ROCKY FLATS SITE

REGULATORY CONTACT RECORD 2016-03

Purpose: Geoprobe Investigation of the Groundwater System Upgradient of the Original Landfill and the Soil Disturbance Review Plan

Contact Record Approval Date: July 28, 2016

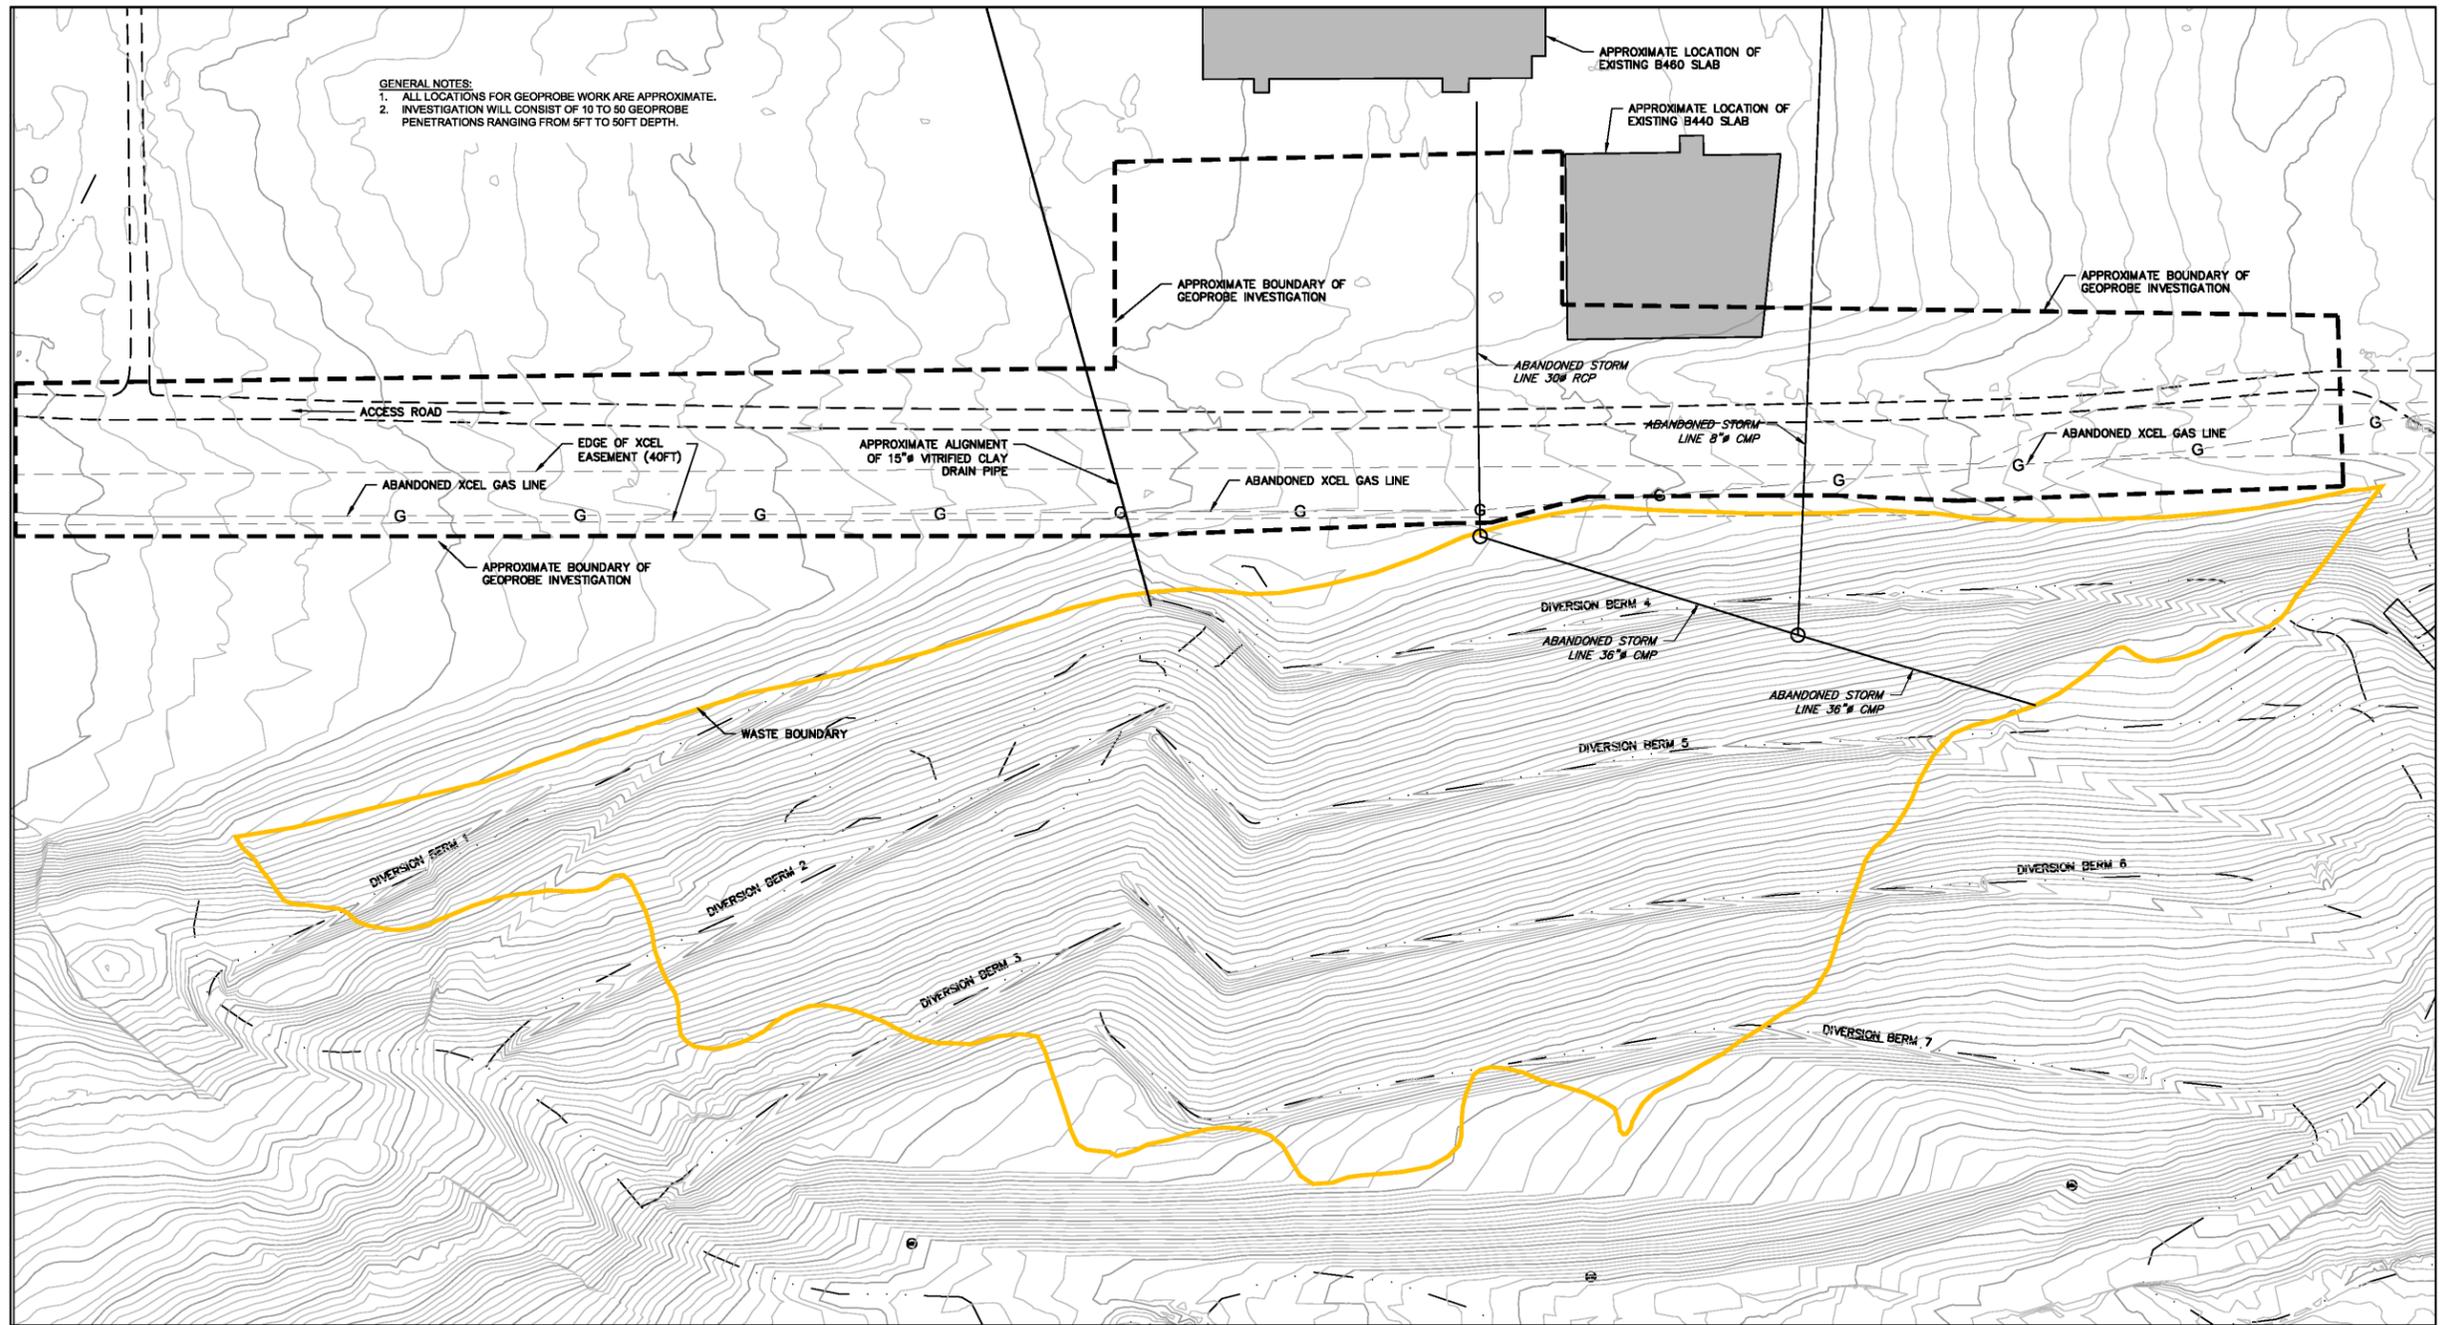
Proposed Approach: A Geoprobe (a direct push drilling rig) will be used to better identify the expected conduits of groundwater flow and to install small wells or piezometers in these areas to better understand the characteristics of groundwater. The investigation area upgradient of the OLF is identified in Figure 1. The number of potential holes will vary, depending on field results, from 10 to 50 holes that will be from 5 to 50 feet in depth. Specifically, the Geoprobe will be used to (1) confirm the expected three locations of abandoned piping/bedding materials that may be conduits for groundwater to enter the OLF; (2) install small wells in these conduits to track the movement of the water table; (3) install small wells above the eastern portion of the OLF where the most significant slumping has occurred; (4) install a small well west of the OLF near the abandoned gas line, which may be a conduit for groundwater flow entering the area; and (5) evaluate the water quality in areas that may later be disturbed or where groundwater may be removed as part of the long-term improvements. In all cases, the Geoprobe will be used on the flat bench above the OLF and outside of the waste footprint. This effort is expected to take approximately 2 weeks.

A Geoprobe (a direct push drilling rig) will be used to better identify the expected conduits of groundwater flow and to install small wells or piezometers in these areas to better understand the characteristics of groundwater. The investigation area upgradient of the OLF is identified in Figure 1. The number of potential holes will vary, depending on field results, from 10 to 50 holes that will be from 5 to 50 feet in depth. Specifically, the Geoprobe will be used to (1) confirm the expected three locations of abandoned piping/bedding materials that may be conduits for groundwater to enter the OLF; (2) install small wells in these conduits to track the movement of the water table; (3) install small wells above the eastern portion of the OLF where the most significant slumping has occurred; (4) install a small well west of the OLF near the abandoned gas line, which may be a conduit for groundwater flow entering the area; and (5) evaluate the water quality in areas that may later be disturbed or where groundwater may be removed as part of the long-term improvements. In all cases, the Geoprobe will be used on the flat bench above the OLF and outside of the waste footprint. This effort is expected to take approximately 2 weeks.

As indicated in Figure 1, the slab foundation for Building 460, Consolidated Non-Nuclear Manufacturing Building, lies to the north of the investigation area. The southern edge of the foundation for Building 440, Modification Center Non-Nuclear Building, lies just inside the investigation area. The following abandoned or removed utilities cross through the investigation area: sanitary sewers, electrical power lines, alarm lines, raw water lines, and culverts and storm water drains. It is anticipated that these abandoned utilities may be encountered during the Geoprobe investigation; in fact it is one of the intentions of the investigation to Geoprobe into the storm water drains as appropriate. There is an Xcel Energy abandoned gas line in the investigation area and the Geoprobe investigation near that line will be coordinated with Xcel Energy.

Resolution: Carl Spreng, CDPHE, reviewed the information regarding the proposed soil disturbance and excavation and, has approved this contact record. CDPHE has determined that the proposed activity will not compromise or impair the function of the remedy or result in an unacceptable release or exposure to residual subsurface contamination. CDPHE has also determined that the proposed project meets the rationale and objectives of IC 2.
